LEXINGTON-FAYETTE URBAN COUNTY GOVERNMENT CONTRACT CHANGE ORDER Page 1 of 2	Date	February 17, 2017
	Project	Fire Station #2 Replacement
	Location	Lexington
To (Contractor) Olympic Construction, LLC 216 Bromme Drive Nicholasville, KY 40356	Contract No	013-2016
	Original Contract Amt	\$4,618,900.00
	Cumulative Amount of Previous Change Orders	\$62,387.83
	Percent Change - Previous Change Orders	1.35%
	Total Contract Amount Prior to this Change Order	\$4,681,287.83
	Change Order No	9

CHANGE ORDER NO. 9

Work Changes Proposal Request No. 11 Revised

Project: 13117 Lexington Replacement Fire Station No. 2
City Job No. 161-2015/038-2016

13117
161 2015
C-101

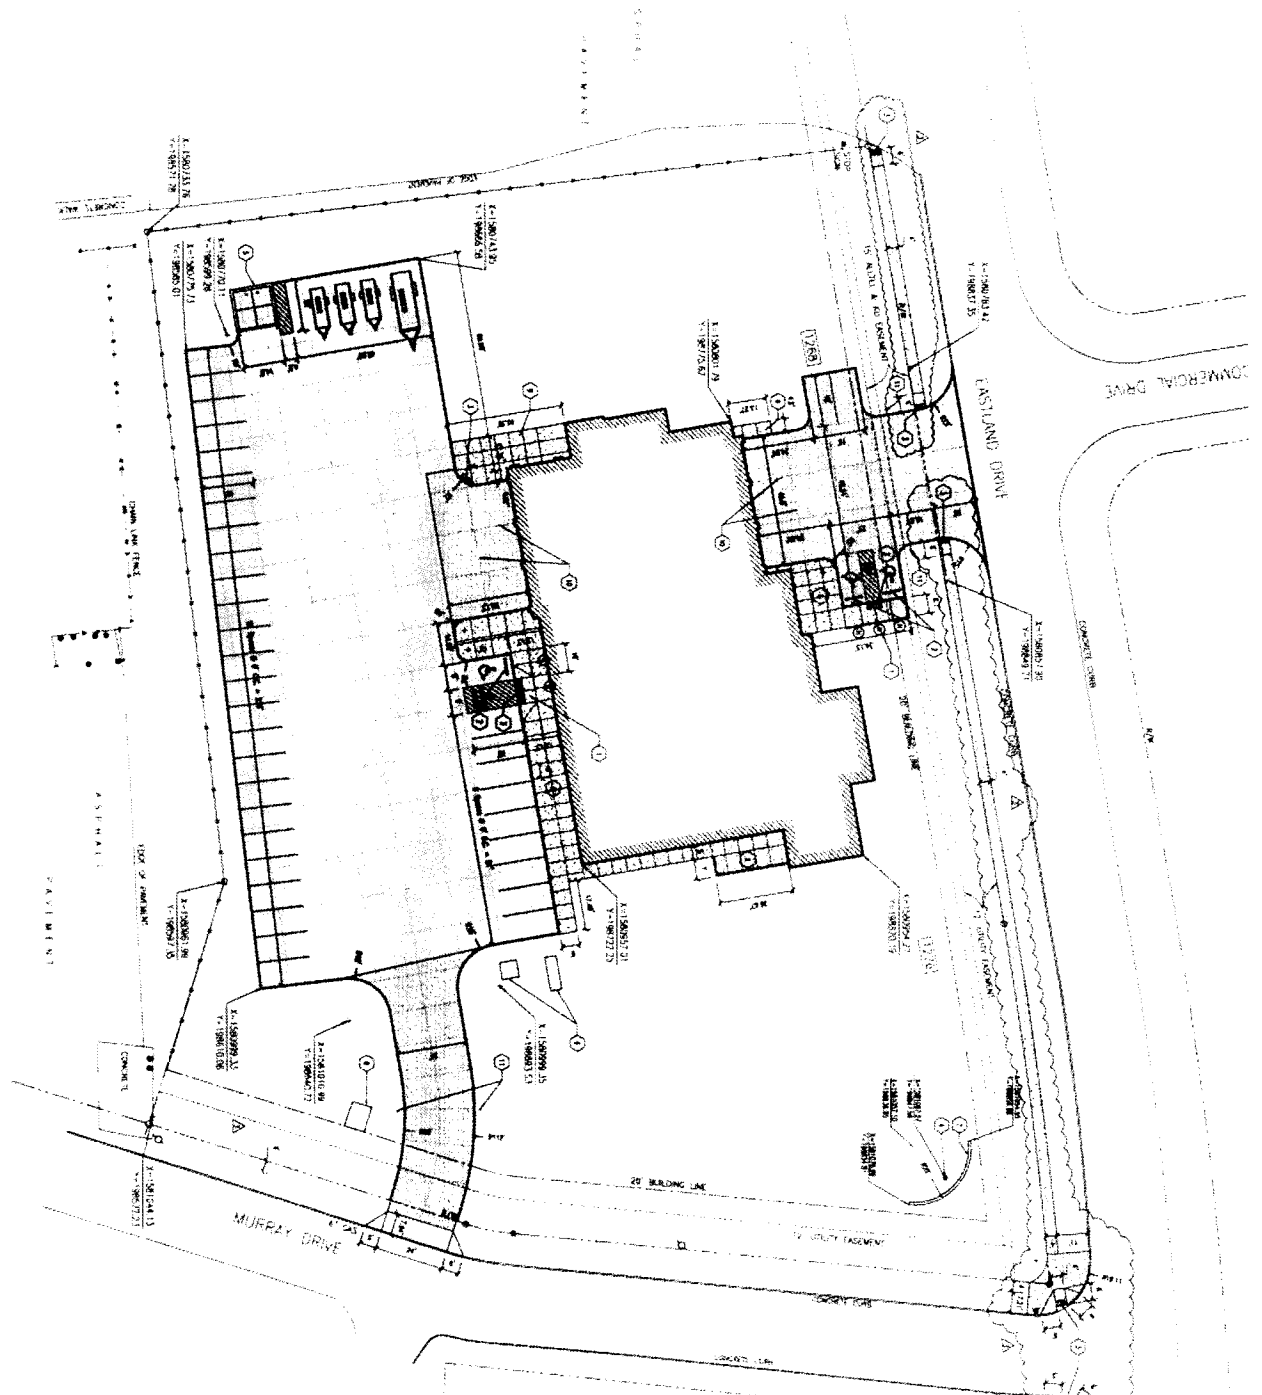
1. Modify curb at Southeast corner of Eastland and Murray Drive to provide ADA accessible curb cut as shown in PR 11.1 per LFUCG Standards. Extend new section of sidewalk to tie into existing sidewalk.
2. Add lighting control relay to a light fixture Type A in Company Officers Room 104 and tie into Zone 2 (Zone with the Bunk Room 109) so it is activated by the Station Alert Zone.
3. Add smoke detector with CO Sensor to Company Officers Room 104.
4. Modify Fire Alarm strobe in Company Officers 104 to low frequency horn/strobe combo unit.
5. Modify Paging Speaker in Company Officers 104 by connecting it to Zone 2 (Zone with the Bunk Room 109).
